**Saddleback Ridge Wind, LLC** // Natural Resource Protection Act  
(NRPA) and Site Location of Development Act applications

- Licensee Exhibit 12  
Letter from SRW to Mark Margerum  
(April 27, 2011)

**Subject: Saddleback Ridge Wind Project, DEP #L-25137-24-A-N, #L-25137-TG-B-N response to comments from public meeting and April 13, 2011 email from Mark Margerum.**

FIGURE 1

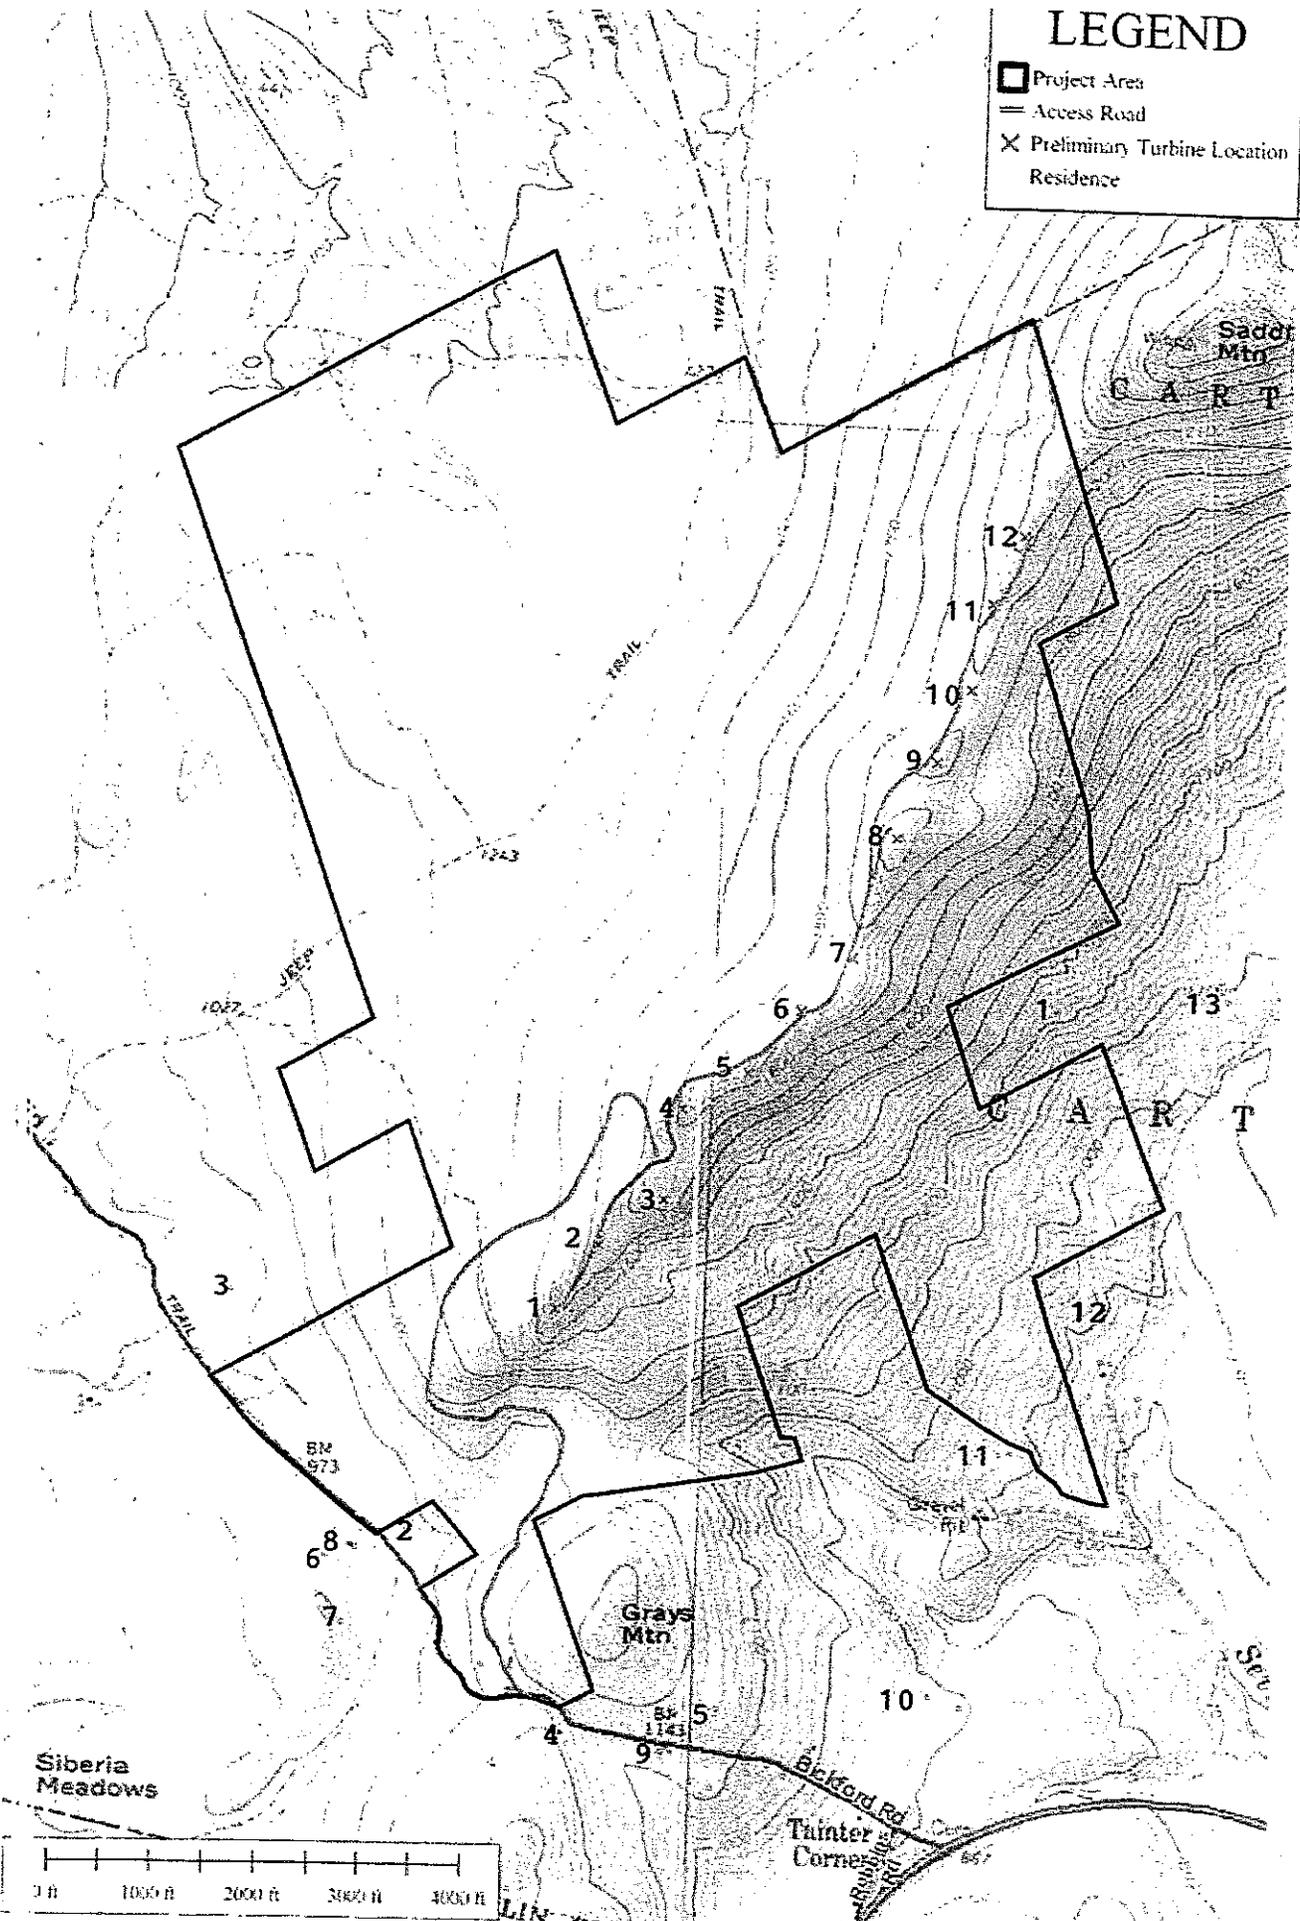
Groundwater: A couple of people expressed concern that blasting might negatively affect the groundwater in their wells. Groundwater protection was addressed in our original Site Law application materials in Section 15 (Groundwater), and we also included a letter (attached again for reference) from industrial seismologist Richard Groll in Section 20 (Blasting) which addressed the effects of blasting on groundwater and specifically on wells in the area near the project. Mr. Groll reviewed a preliminary blasting plan for the project, along with the locations of local residences and the areas where blasting is expected to occur and concluded that "There is no reason to believe that the blasting activity at the Saddleback Ridge Wind Project will disturb the rock structure or composition in a manner that would result in the diminution of the quality or quantity of local drinking water supplies." Mr. Groll also notes that "The proposed blasting operations at this site will not cause damage to the surrounding structures or water wells. The scale of blasting required at this site is commonly employed within 50 feet of occupied dwellings and working water supplies without causing damage." Based on Mr. Groll's assessment, we feel that the Project will have no impact on local drinking water wells; nevertheless, to address these concerns we will offer both pre- and post-construction water well tests to all residences within 3,500 feet of blasting activity. The pre-construction well testing will be incorporated into the pre-blast survey. A detailed spill prevention and control plan will be submitted to the department prior to operation.

The proposed blasting activity will occur on access roads within the applicant property and at the foundations for the wind turbines. The depth of rock excavation will range from 5 to 14 feet in both the access road and at the turbine foundations. Blasting is not anticipated at the entrance to the site, as there is an existing road leading into the property. The nearest homes to areas of anticipated excavation for the access road on the site are on Jackson Hole Drive and Bickford/Winter Hill Road. The nearest residences to excavation for the turbines will be off Mason Road, east of Saddleback Ridge. Table 1 is a tabulation of the locations and distances seen in Figure 1. Figure 1 is a map demonstrating the locations of the nearest residences to the anticipated areas of excavation for the project.

The proposed blasting operations at this site will not cause damage to the surrounding structures or water wells. The scale of blasting required at this site is commonly employed within 50 feet of occupied dwellings and working water supply wells without causing damage. The blasting process is highly refined and scientific. This firm routinely demonstrates the reliability of the process to homeowners living in close proximity to blasting operations.

# MAP A

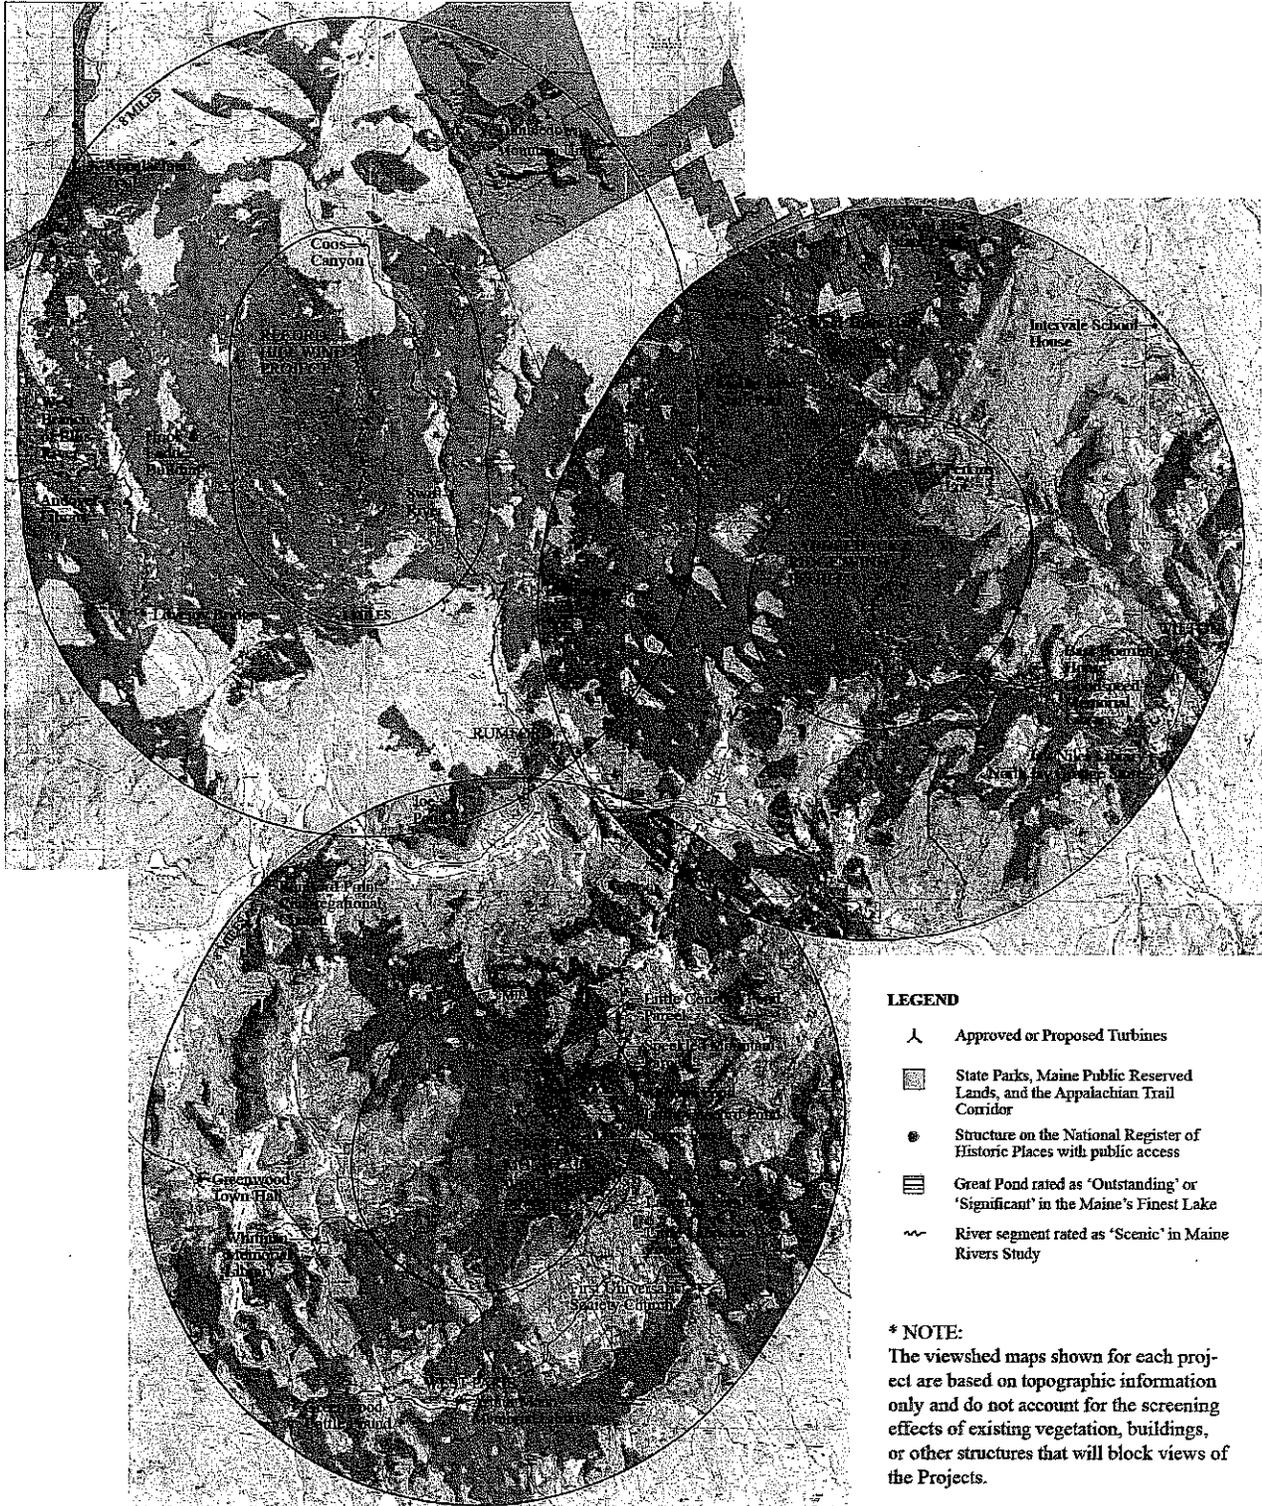
Cumulative Visual Impact: The question was raised whether there would be visibility of any other pending, permitted or operating wind projects from scenic resources of state or national significance within the 8-mile viewshed of the Saddleback Ridge Wind Project. The only other pending, permitted or operating projects that we are aware of within a 16-mile radius of the Project are the Record Hill project (permitted and partially constructed) and the Spruce Mountain Project (permitted and currently under appeal). There have been press reports about a potential First Wind project in the Rumford/Roxbury area, but we are not aware of any permit application having been filed on that project. Similarly, there is a project under development by Patriot for Colonel Holman Mountain in Dixfield and Canton Mountain in Canton, but both are in earlier development stages and no applications have been filed.

To evaluate the cumulative impact of wind projects on scenic resources of state or national significance, we had our visual expert prepare a viewshed analysis of the Record Hill, Spruce Mountain, and Saddleback Ridge Wind Projects (see attached maps prepared by Terrence J. DeWan & Associates). Map A shows the viewshed analysis based on the more conservative topography data only while Map B shows the viewshed analysis of the Saddleback Ridge and the Spruce Mountain Projects based on vegetative landcover data (the Record Hill vegetative landcover viewshed data is not available) Halfmoon Pond is the only scenic resource of state or national significance that is located within eight miles of the Saddleback Ridge Wind Project and one or more other projects. From Halfmoon Pond, tips of 6 Saddleback turbines may be visible above the treeline, but there will not be any visibility of the Record Hill turbines due to intervening topography.
